November 2017
FL746A
NHTSA #17V-588
Transport Canada #2017-460

Subject: Western Star Battery Cable Routing

Models Affected: Specific Western Star 4700 model vehicles manufactured December 17, 2012, through July 14, 2017, with all wheel drive front axles.

Fig. 1, Battery Cables Near the Driveline

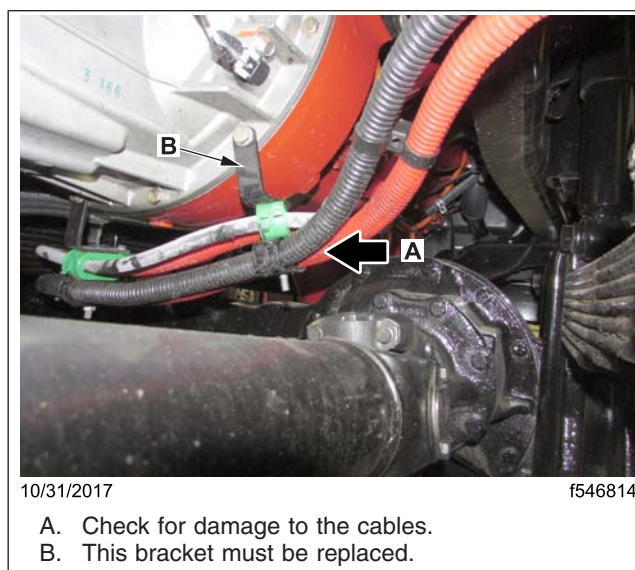
On certain vehicles, articulation of the All Wheel Drive (AWD) axle yoke may create an interference between the AWD yoke and the battery cable routing. An interference between the battery cables and the yoke may cause shorting of the lines and a possible fire.

4. If the battery cables are not damaged, Continue with step 5.
If the battery cables are damaged (not just the convolute tubing), the battery cables must be replaced. Go to **Battery Cable and Bracket Replacement** on page 8.
5. Loosen the nut on the battery cable clamps to the left of the driveline. This will allow for any needed slack when positioning the cables on the new bracket.

Fig. 2, Loosening the Nut on the Bracket

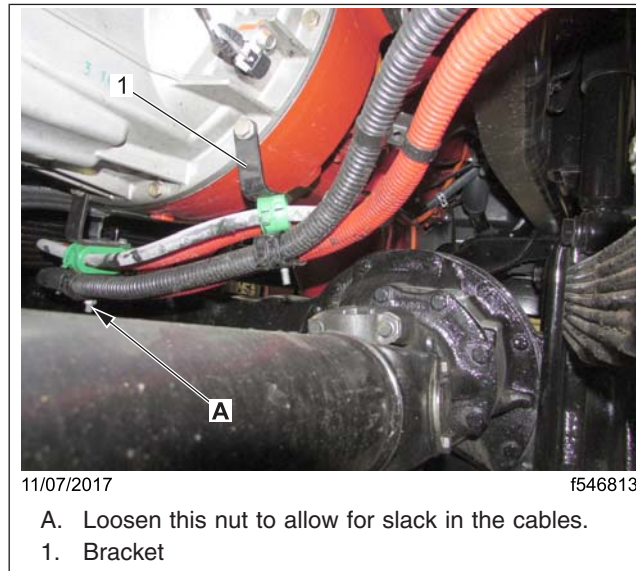
NOTE: The bracket fastener must be removed before the clamps will slide completely free of the old bracket.
See [Fig. 2](#).

6. Remove the bracket above the driveline, and replace it with the new bracket supplied in the kit. Mount the cables on the new bracket, as shown in Fig. 5, with the two clamp groups side-by-side. In this installation, the battery cables are to the rear, and the alternator cables are forward. Continue to step 11, on page 9.

Fig. 3, Bracket Below the D-Pop Stud

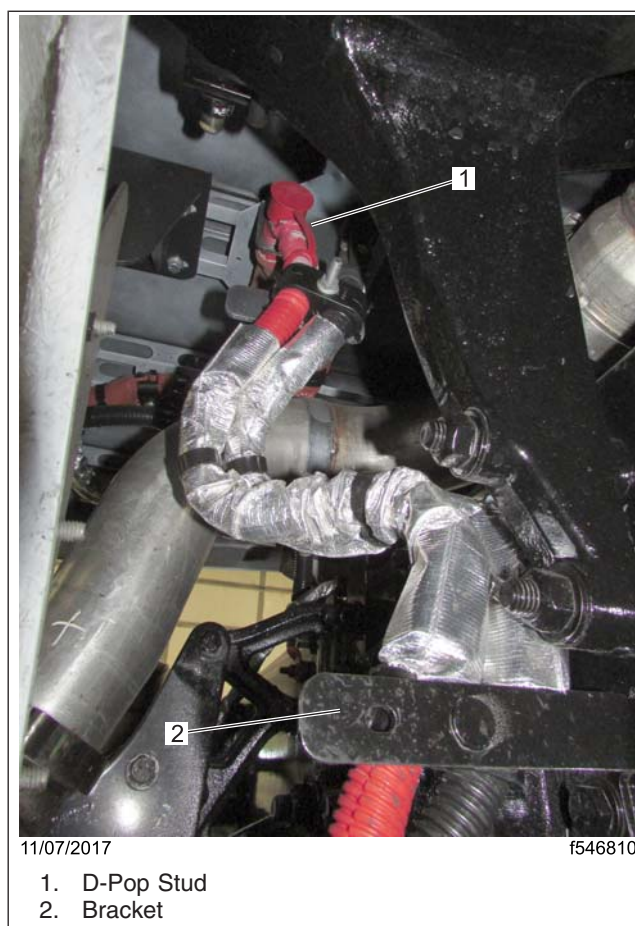
NOTE: The bracket just below the d-pop stud can be bent forward to allow the cable clamp to be removed. See [Fig. 3](#).

2. Remove the negative and positive cables as a set from the starter to the d-pop stud on the passenger side frame rail. This will allow the positioning of all of the clamps and cable ties before installing the new cables.
